# Wisconsin Department of Transportation

**Proposal #16: 1500-37-71, WISC 2018 470**  
**Waldo Blvd, City of Manitowoc**  
**Fleetwood Drive – 8<sup>th</sup> Street**  
**USH 10**  
**Manitowoc County**

## Letting of December 11, 2018

This is Addendum No. 01, which provides for the following:

Addendum No. 01  
 ID 1500-37-71/72  
 ID 1500-47-71  
 ID 4570-12-71/72  
 Revised Sheet 40  
 December 3, 2018

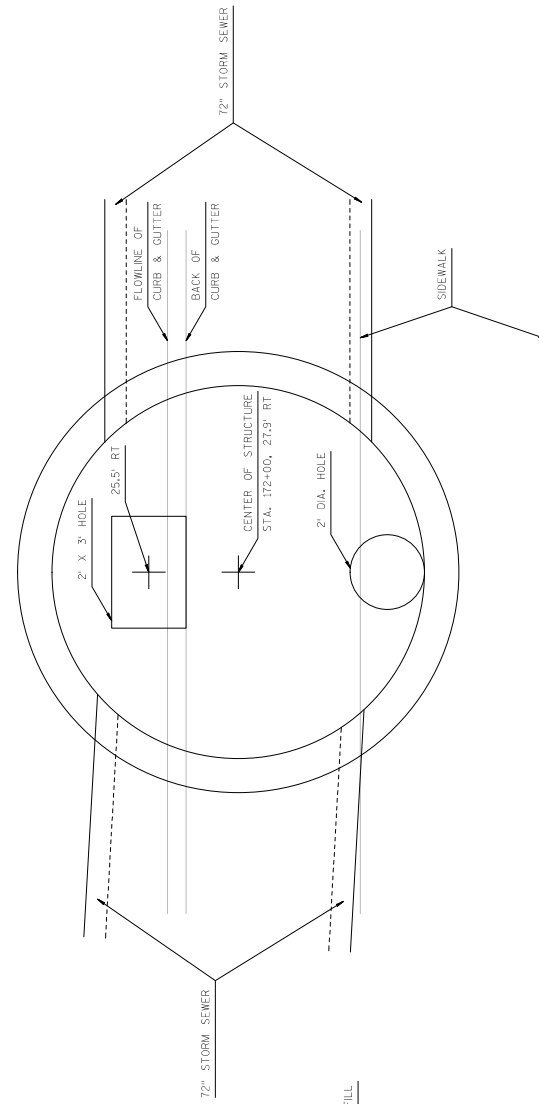
<b>Revised Plan Sheets</b>	
Plan Sheet	Plan Sheet Title (brief description of changes to sheet)
40	Construction Details (Note revised)
45	Construction Details (Revised detail title to reflect a new bid item)
48	Construction Details (Modified base offset and top elevation)
51	Construction Details (Modified insulation thickness)
137	Storm Sewer Removal Plan (Revised note based on modified storm sewer layout.)
139	Storm Sewer Removal Plan (Revised trunk line removal/abandoning limits)
140	Storm Sewer Removal Plan (Revised trunk line removal/abandoning limits)
141	Storm Sewer Removal Plan (Revised trunk line removal/abandoning limits)
179	Storm Sewer (Adjusted MH-126.4 and the pipe from MH-126.4 to MH-126.0)
182	Storm Sewer (Adjusted the location of CB-126.1, the layout of the 12-inch PVC pipe within the 54-inch existing storm sewer, MH-126.2, MH-126.4, and the pipes from CB-126.1 to MH-126.2 and from MH-126.2 to MH-126.4)

11 TRENCH INSULATION  
 NOT TO SCALE

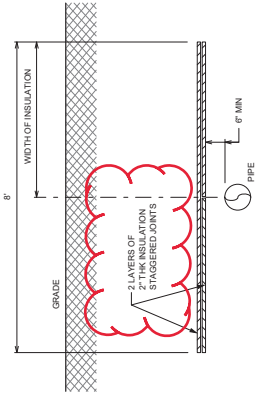
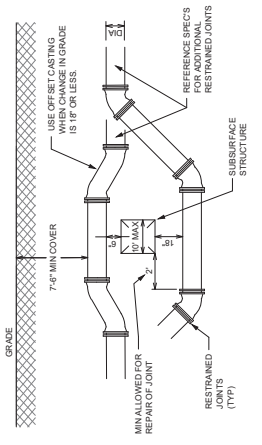
**185. Trench Insulation 4-Inch, Item SPV.0165.101.**

Furnish extruded closed-cell polystyrene board complying with ASTM C578, Type IV, minimum 25 psi compressive strength, minimum thermal resistance (R-value at 75 deg F) of 5.0 per 1-in. thickness.

USH 10/STH 42 & CTH R (RAPIDS AVE)	
CITY OF MANITOWOC	
MANITOWOC COUNTY	
SIGNAL NO:	N/A
CABINET TYPE:	TS2
CONTROLLER TYPE:	PRC-102
DATE:	11/18
PAGE NO.	2 OF 2
SHEET NO.	237

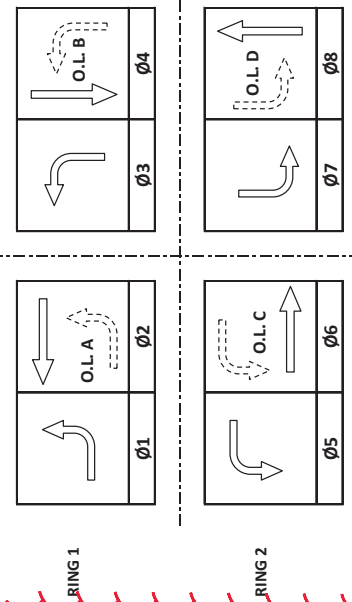
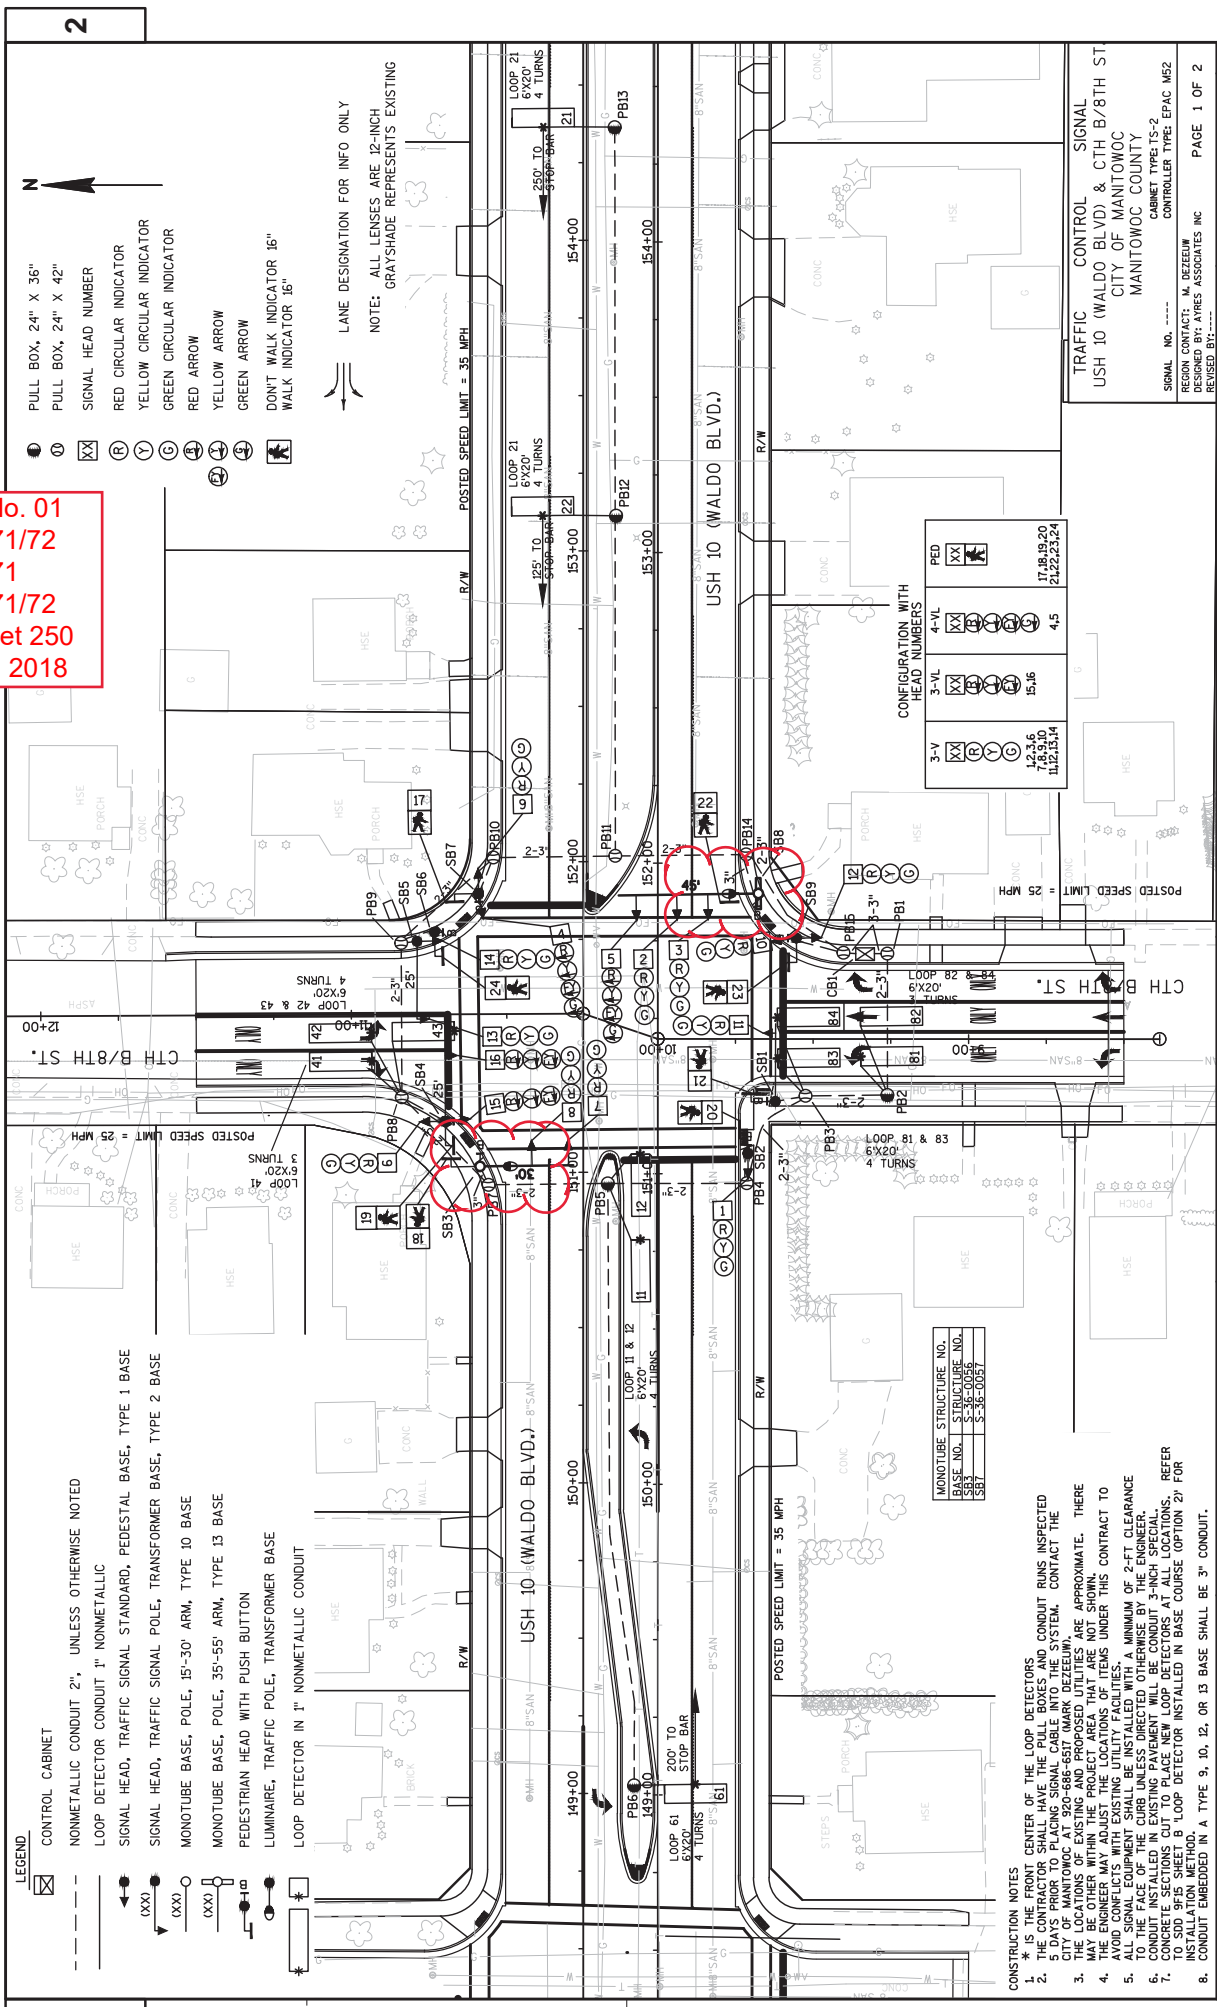
236	Traffic Signals (Changed signal head type)
237	Traffic Signals (Updates due to new signal heads)
250	Traffic Signals (Added luminaires)
339	Miscellaneous Quantities (Modified reflecting the revision to the storm sewer trunk line removal/abandoning limits)
340	Miscellaneous Quantities (Modified reflecting the revision to the storm sewer trunk line removal/abandoning limits)

Addendum No. 01  
ID 1500-37-71/72  
ID 1500-47-71  
ID 4570-12-71/72  
Revised Sheet 783  
December 3, 2018

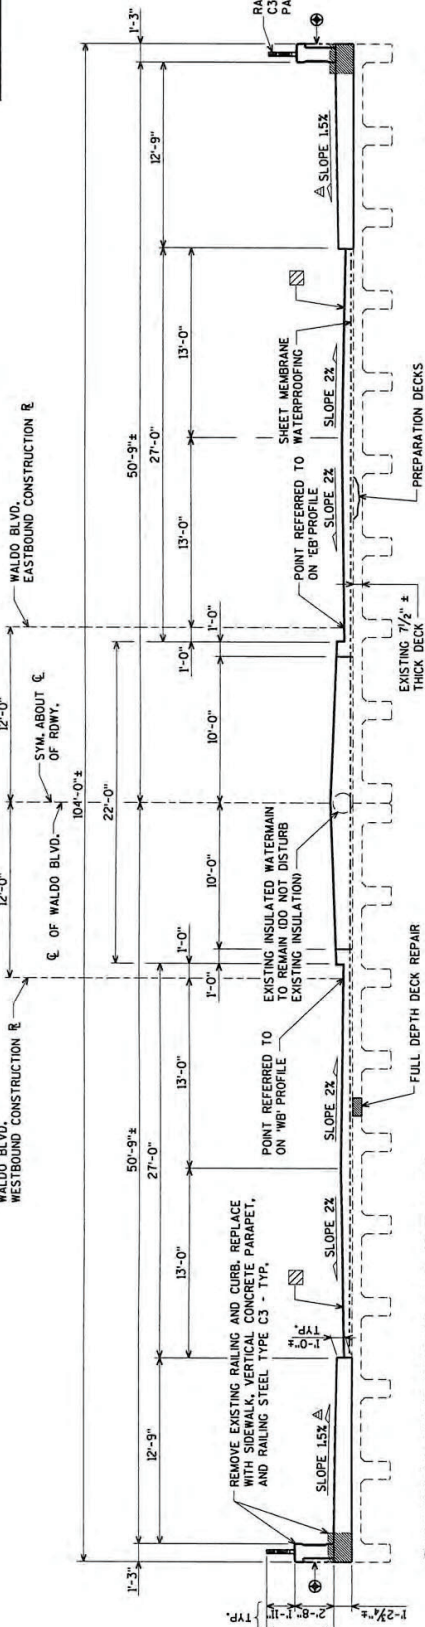
476	Miscellaneous Quantities (Revised Quantities)
478	Miscellaneous Quantities (Added Steel Casing Pipe)
479	Miscellaneous Quantities (Updated item to Trench Insulation 4-Inch)
480	Miscellaneous Quantities (Updated item to Trench Insulation 4-Inch)
783	Structure B-36-900 (Quantity changes)
